City of Puyallup

DEVELOPMENT REVIEW TEAM (DRT) LETTER	
DRT #	1
PERMIT #	PLPSP20220155
PROJECT NAME	Fortress Puyallup
PERMIT TYPE	Preliminary Site Plan
PROJECT DESCRIPTION	Construct an approximately 135,900 square foot warehouse with truck loading bays and associated parking. Project is required to go through industrial administrative design review and will include landscaping, storm water controls, utilities, and other site improvements as required.
SITE ADDRESS	240 15TH ST SE, PUYALLUP, WA 98372
PARCEL #	0420274126
ASSOCIATED LAND USE PERMIT(S)	
APPLICATION DATE	October 26, 2022
APPLICATION COMPLETE DATE	November 02, 2022
PROJECT STATUS	<u>Active Development Review Team (DRT) review case – resubmittal required.</u> Please address review comments below and resubmit revised permit materials and by responding in writing to the remaining items that need to be addressed.
APPROVAL EXPIRATION	N/A – Active permit application, not approved

General Comments – Markups from Redlines

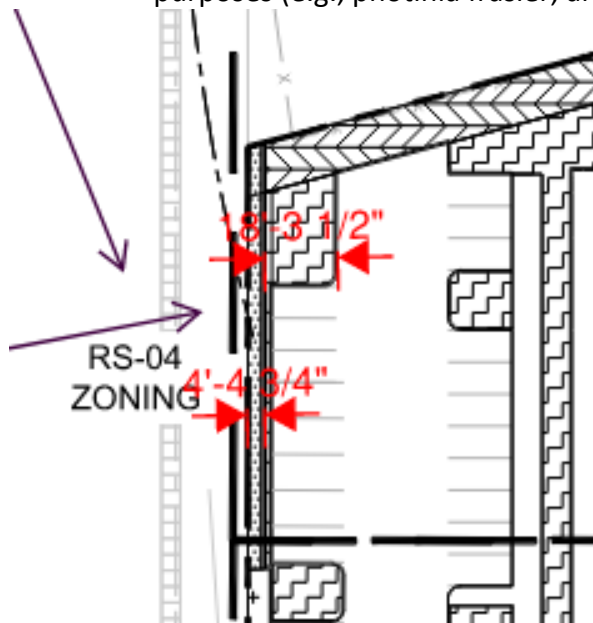
- Signage is applied for and permitted through a sign permit and subject to the special sign code provisions for the ML zone found in PMC 20.60.055 [exterior elevations, A2.00]

- You have noted that there is a water easement that crosses through where the landscaping is required on the northern portion of the site along the interior side yard. In the pre-app notes, planning commented that although trees may not be able to be planted here due to the waterline, you would need to substitute trees for adequate shrubbery and other vegetation required in the landscape buffer. Vegetation is required to be planted in this area interior to the site.
The minimum distance from underground water, sewer, or storm is 10'. [landscape plans, L0.01]

- Landscape islands every eight stalls are required for trailer parking [landscape plans, L0.01]
- Perimeter landscaping required to be 12' [landscape plans, L1.10]

- Parking landscape islands not meeting required widths
Perimeter: 12' wide
Internal: 15' wide
[landscape plan, L1.10]
- Trees required to be planted in landscape area abutting wall [landscape plans, L1.10]

- Trees required to be planted in the blank wall landscaping [landscape plans, L1.10]
- Parking landscape islands not meeting required widths
Perimeter: 12' wide
Internal: 15' wide
[landscape plan, L1.11]

- Please add another wide vegetative screen wall here [elevations, A2.00]
- The perimeter of all parking areas and associated access drives which abut public right-of ways shall be screened with on-site landscaping, earth berms, fencing, or a combination of both [landscape plans, L1.10]

- PMC 20.26.400 (1) requires that the 15 wide landscape strip along blank walls include a mixture of medium to large evergreen conifer and deciduous trees and shrubs. Please include trees on the landscape plan chosen from class II, II, or IV street tree list in the VMS. [landscape plans, L1.10 & L1.11]

- 3. Please add soil cells to the 66 blank wall landscape area [landscape plans, L1.10 & L1.11]
